**Re: Second Submission Review – Fitzsimons Innovation Community Subdivision Flg No 3 - Final Plat**  
Application Number: **DA-1233-45**  
Case Numbers: **2020-3024-00**

## Second Submission Review

D. CONCEPTUAL E. 23RD AND RACINE STREET INTERSECTION WITH TURN LANE ::

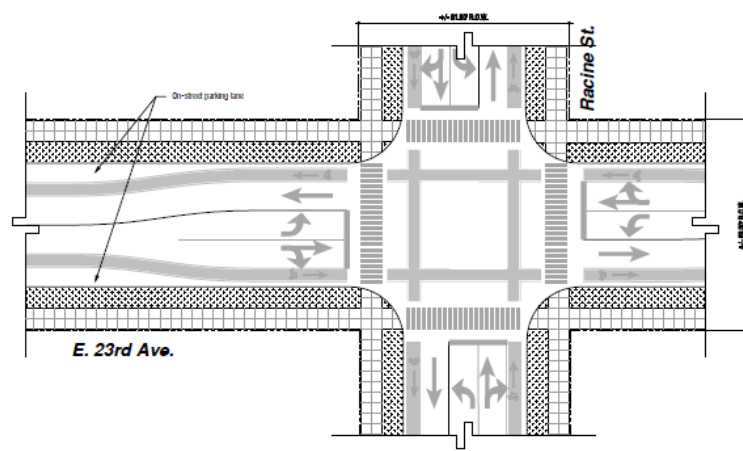
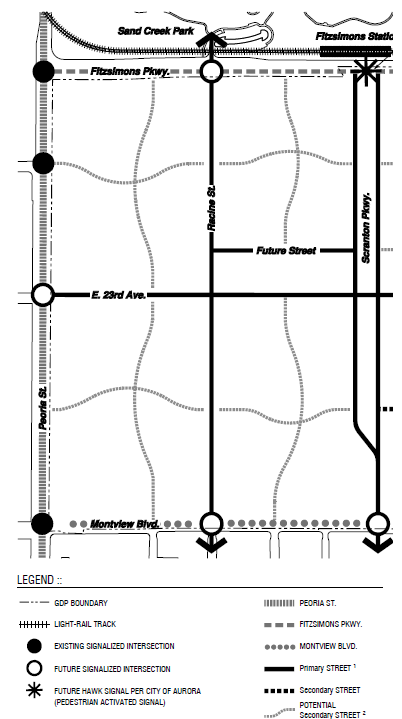
- 2A. Additional discussion is necessary regarding the request for a roundabout. I suggest continued collaboration on this issue.
- 2B. Planning does not support the construction of a roundabout at this location as it does not comply with the Fitzsimons Innovation Community GDP.
- 2C. The GDP
- 2D. The E 23rd Avenue and N Racine Street intersection is illustrated in the GDP as a typical two-lane street with turn lane at the intersection. While it is a conceptual illustration, the shift to a roundabout does not comply with the GDP, which was reviewed and approved by Public Works with Fitzsimons GDP Amendment No. 6. The standards in the GDP will prevail where specific street intersections are illustrated.
- 2E. A GDP design standard requires buildings to front the street. A roundabout causes buildings to be shifted back and the design standard will not be met as a result.
